Access Compliance Report

Public Rights-of-Way

Intersection ID: 19432	Main Street: REXFORD_RD	Cross Street: COCA-COLA PLAZA	Location: SW
ADA ID: 94B2578C51D9	Ramp Type: Perp	Initial Pass/Fail: Fail	Overall Compliance: No
		Severity Score: 22.5

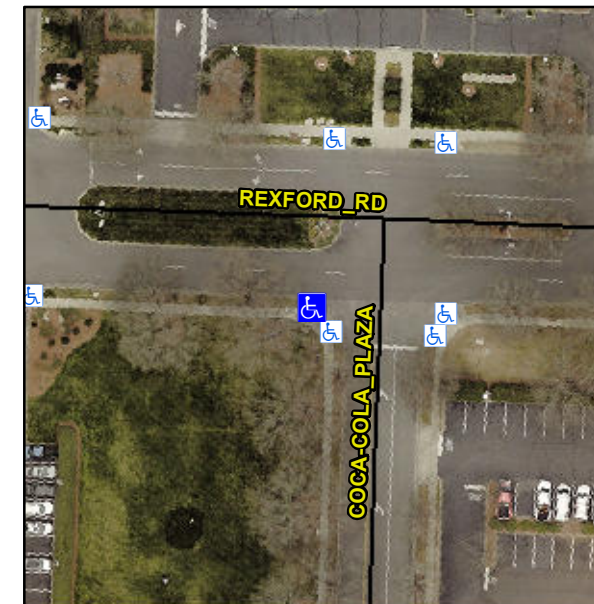
R304.5.1, R304.2.2, R304.5.3

Compliance	Description	Data	Compliance	Description	Data
N/A	Ramp Length (in)	129.5	No	Ramp Slope (%)	9.2
No	Ramp Width (in)	46.0	No	Ramp XSlope (%)	3.0
N/A	Flare Type LT	N/A	N/A	Flare Type RT	N/A
N/A	Flare Slope LT (%)	N/A	N/A	Flare Slope RT (%)	N/A
N/A	Flare Traversable LT?	N/A	N/A	Flare Traversable RT?	N/A
N/A	Landing Length (in)	N/A	N/A	DWS Provided?	N/A
N/A	Landing Width (in)	N/A	N/A	DWS Contrast?	N/A
N/A	Landing Slope (%)	N/A	N/A	DWS Length (in)	N/A
N/A	Landing X Slope (%)	N/A	N/A	DWS Full Width?	N/A
N/A	Landing Curb? (Y/N)	N/A	N/A	DWS Offset (in)	N/A
N/A	Shared Landing?	N/A			
N/A	Gutter Ponding?	N/A	N/A	Gutter Slope (%)	N/A
N/A	Gutter Lip Ht (in)	N/A	N/A	Gutter X Slope (%)	N/A
N/A	Painted X Walk1?	No	N/A	Painted X Walk2?	N/A
	X Walk 1 Direction	To N		X Walk 2 Direction	N/A
N/A	X Walk 1 Width (in)	N/A	N/A	X Walk 2 Width (in)	N/A
	X Walk 1 Slope (%)	3.3		X Walk 2 Slope (%)	N/A
	X Walk 1 X Slope (%)	2.1		X Walk 2 X Slope (%)	N/A

Remove & Replace Entire Ramp.
